DRC - STIPULATED SCHEME
 Computer Rendering of Illumination
 with Vehicles

West Valley Transportation
 Parking Area

R-3

WCT PARKING FACILITY
COMPUTER-PROJECTED RENDERING of ILLUMINATION
 provided by
ORIGINAL PERMITTED LIGHTING SCHEME*

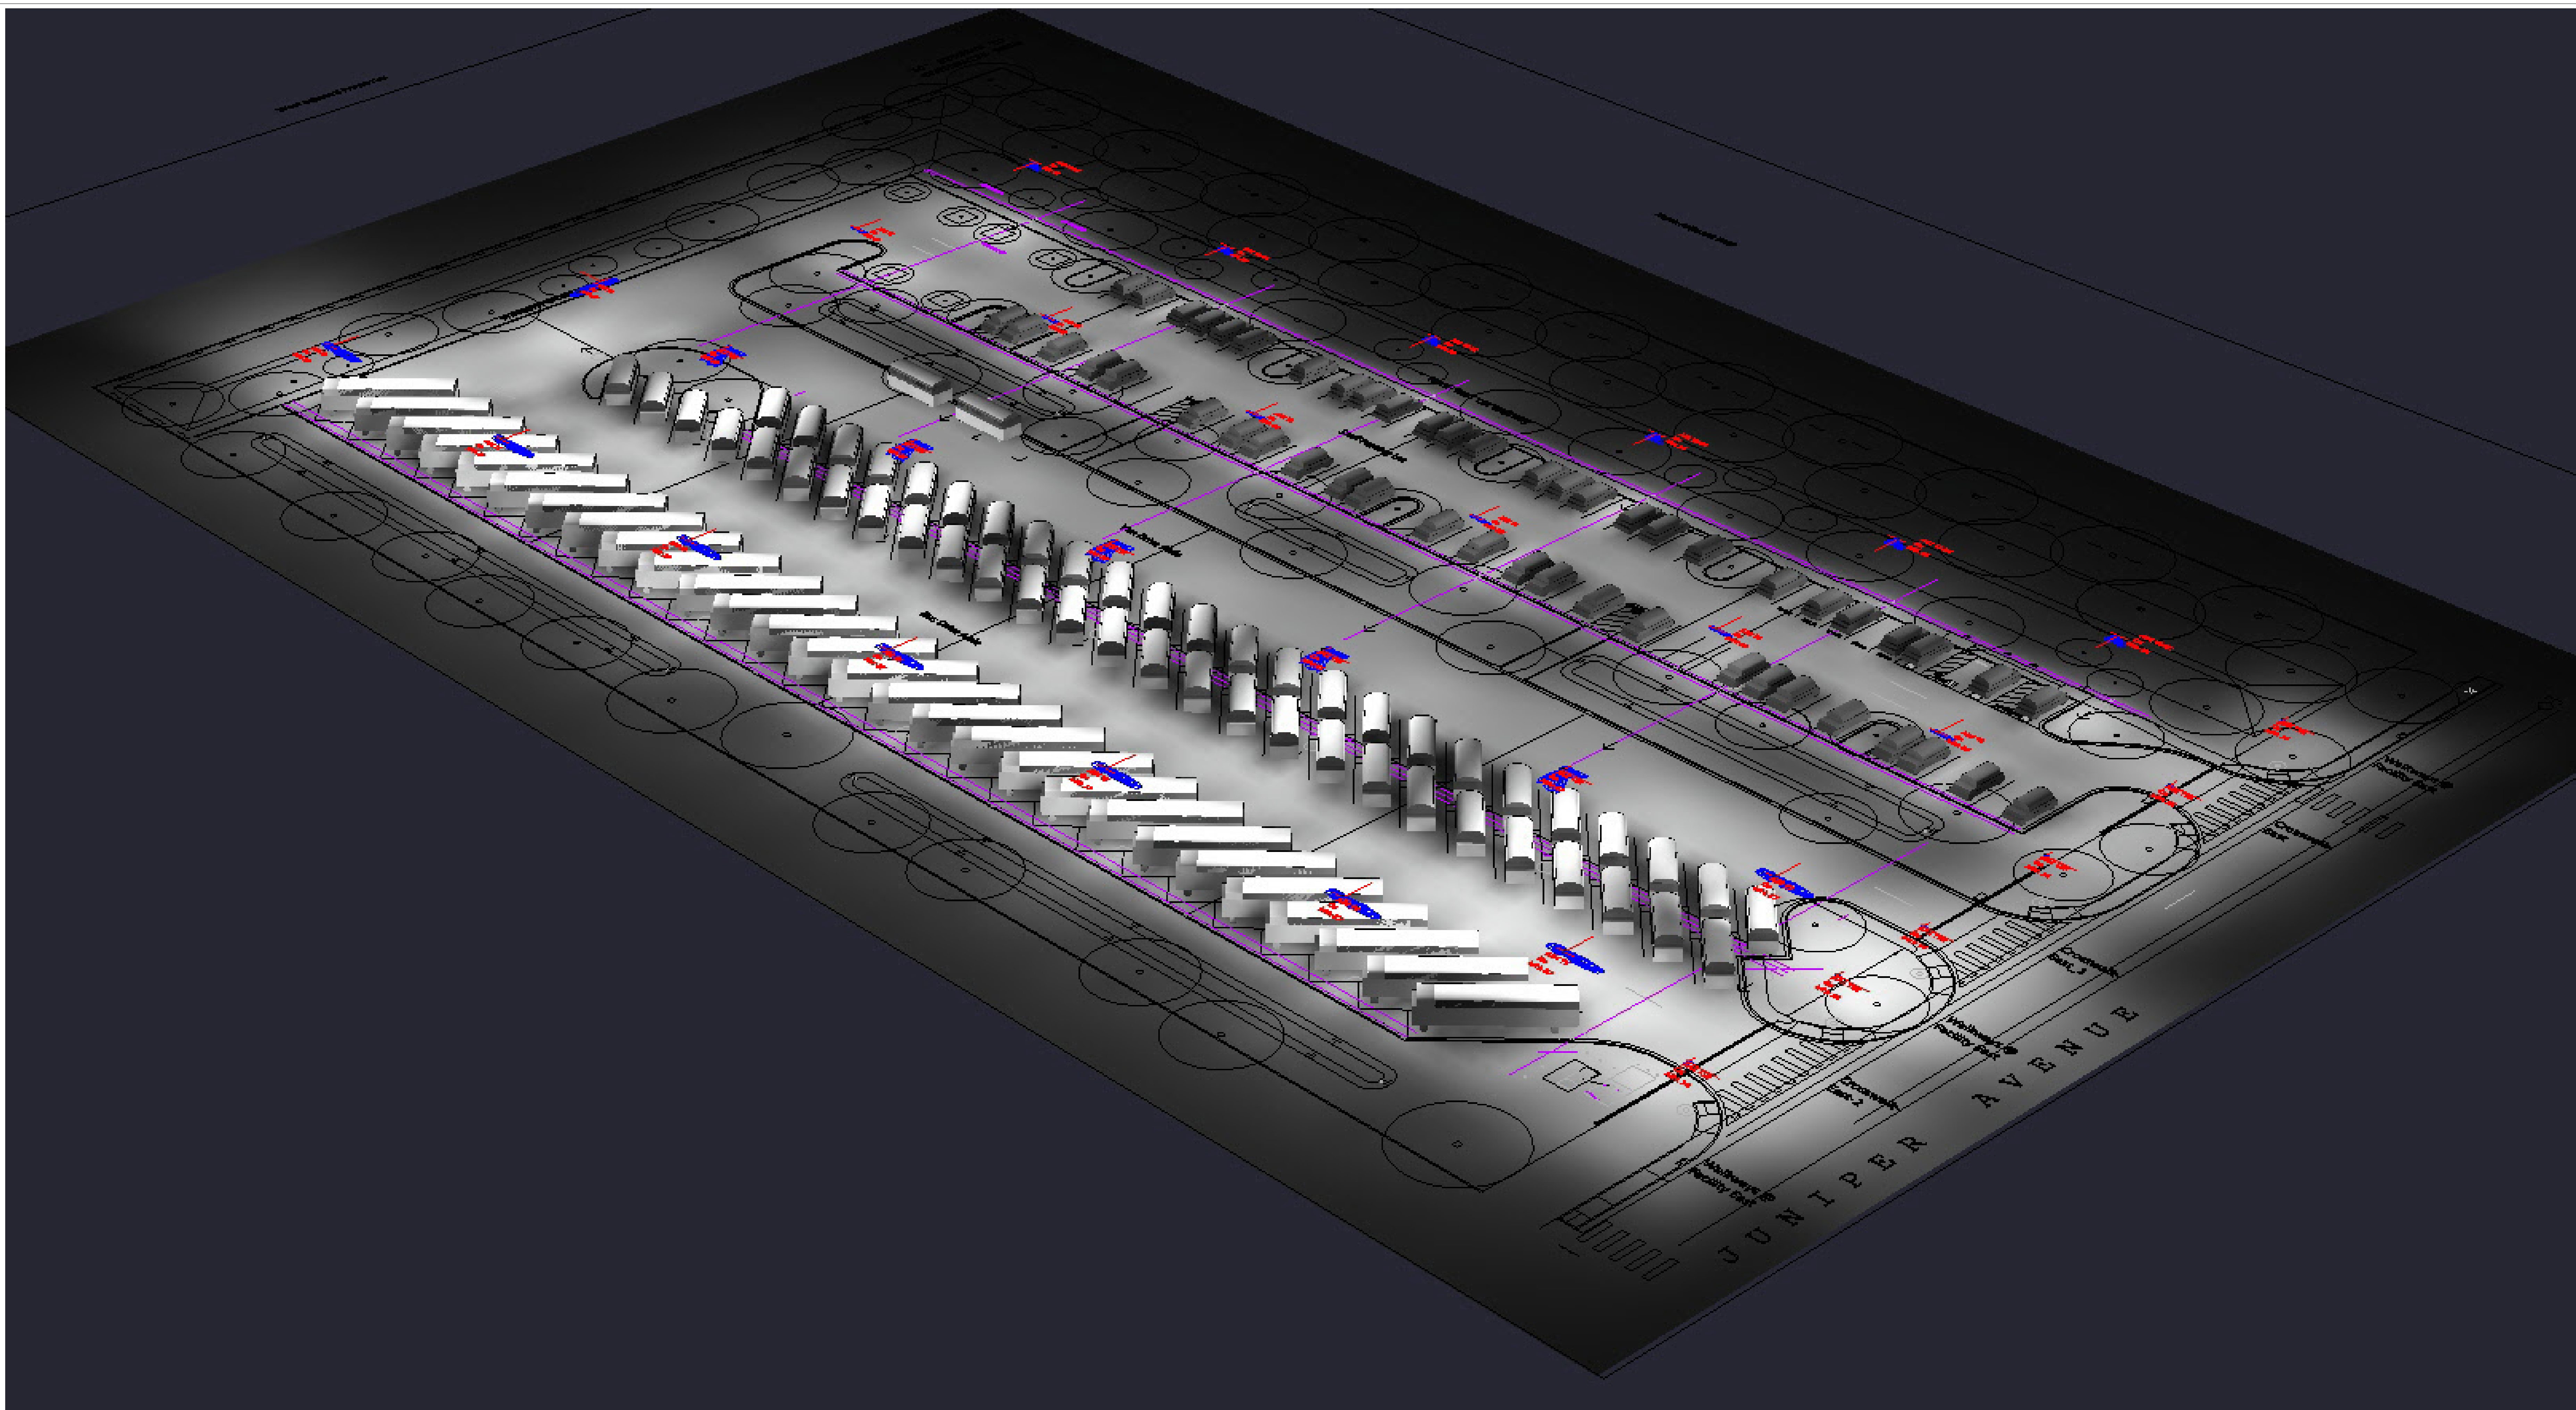
***ADJUSTMENTS to ORIGINAL PERMITTED LIGHTING SCHEME:**

- 1) Wattage/Light Output ratings for most luminaire heads have been reduced, to lower overall light levels, while maintaining levels that exceed Industry minimum recommended criteria.
- 2) Light Poles at South edge of large Bio Retention Area Relocated RELOCATED to North edge, LOWERED from 35ft to 25ft high, to eliminate excessive shadowing of Staff Parking Lot from numerous large Oak Trees planned in the Bio Retention area.
- 3) Deleted (6) high-output (170w) Van/Bus Lot luminaire heads entirely from relocated Poles.

- ~ All other Original Pole Luminaire *locations & heights* remain unchanged.
- ~ Projected Light Levels based on originally-specified 3000 deg. K CCT LED light sources (See C.
- ~ 2700 deg. K CCT LED's are available, but are 14% LESS EFFICIENT than the 3000 deg. spec'd & calc'd here.
- ~ Projected Light levels with 2700 deg. K LED's are 86% of those shown on the Calculations Sheet, C-1

WCT PARKING FACILITY
COMPUTER-PROJECTED RENDERING of ILLUMINATION
 provided by
PROPOSED COMPROMISE LIGHTING SCHEME

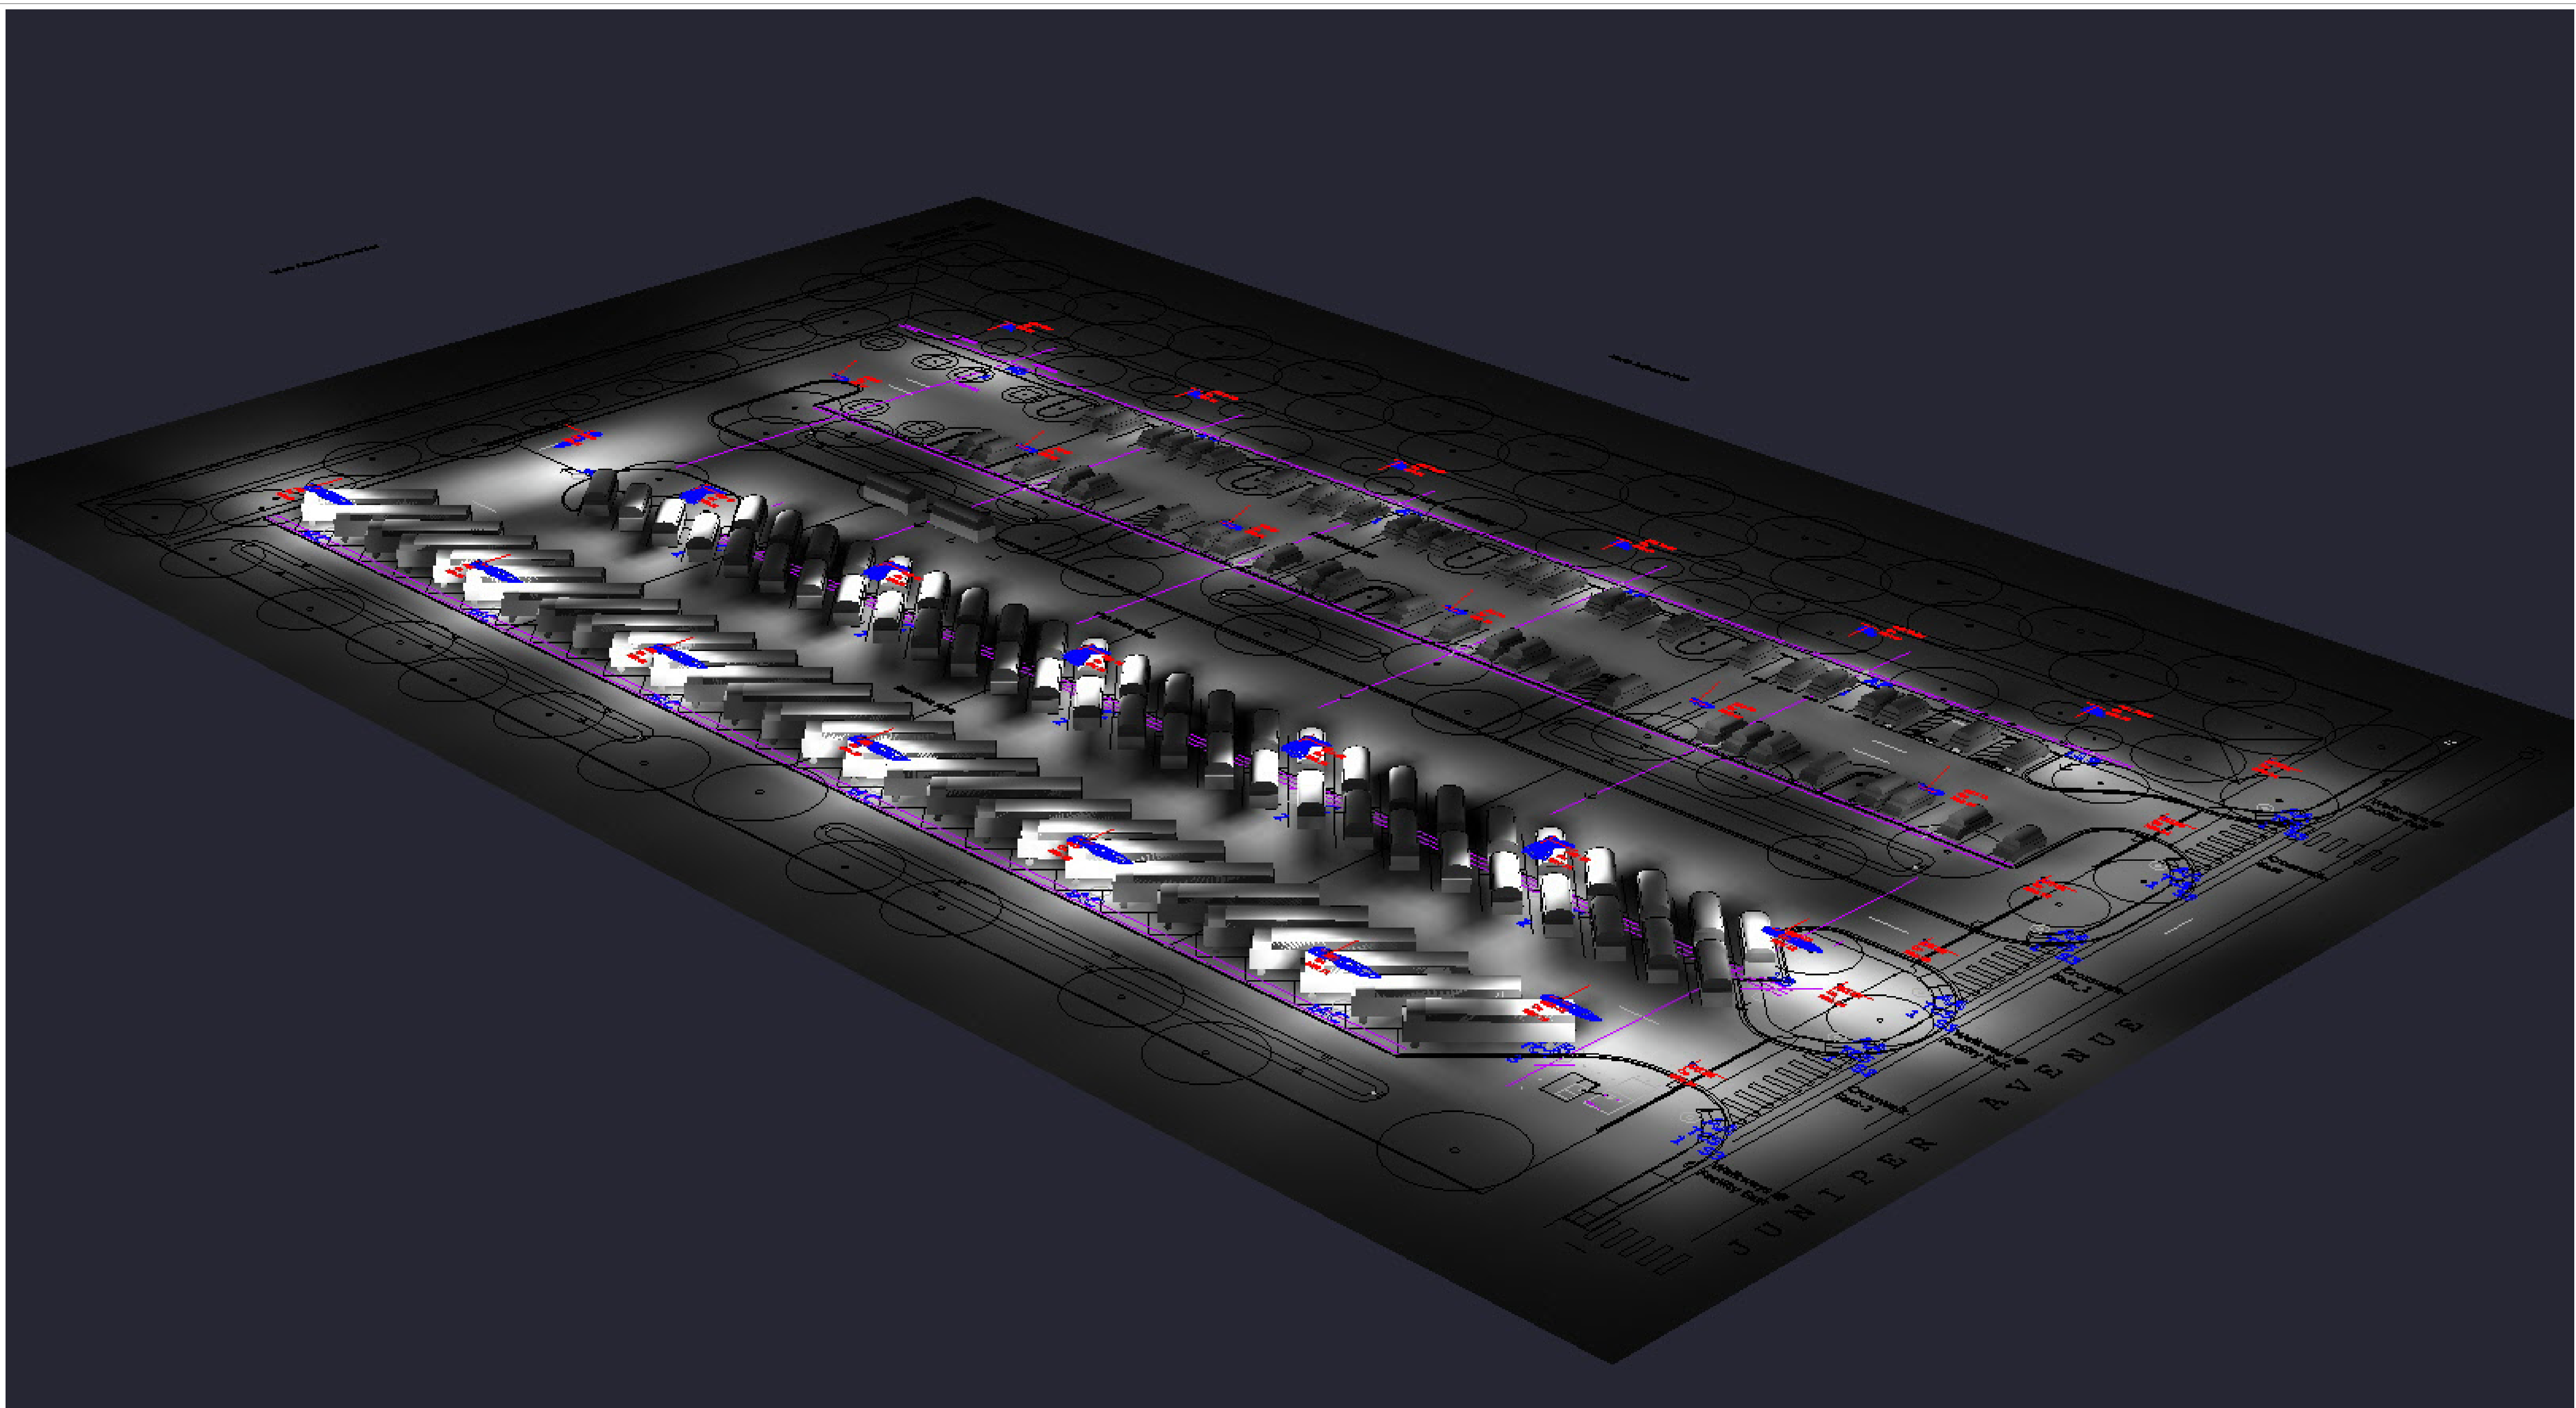
PROPOSED COMPROMISE LIGHTING SCHEME MODEL:

- 1) Light Pole *locations*, luminaire *Types*, *wattages* and *output ratings* used for this Computer Model are **IDENTICAL** to those included in the (Adjusted) ORIGINAL PERMITTED SCHEME.
- 2) All Luminaire heads at Bus/Van Lot: set at 27ft above finished grade.
- 3) All Luminaire heads at Staff Auto Lot: set at 20ft above finished grade.
- 4) Although 2700 deg. K LED's are available now as a standard Option, they are 14% LESS EFFICIENT than 3000 deg. LED'S specified, and so these were used as the basis for this Computer Model. To determine light levels for this Scheme using 2700 deg. K LEDs: take 86% of *fc levels* shown on Sheet C-2.

~ While this Compromise Scheme cannot match the performance of the ORIGINAL PERMITTED SCHEME in the difficult category of providing sufficient lighting between parked buses and vans, it still does perform very well, and dramatically better than the Scheme using all the same locations and luminaires, set on the very much too-short poles that the DRC has stipulated.

~ Even at this reduced compromised height (27ft), the system is still able to meet Industry standards for Average light levels, Uniformity of illumination, and to achieve acceptable lighting at the difficult spaces between the large Buses and Vans that will be parked at this Facility nightly (as illustrated on Sheet C-2, even with the reductions in light output that have been made from those originally specified, and the deletion of the (6) most powerful luminaire included in the Original Permit Set.
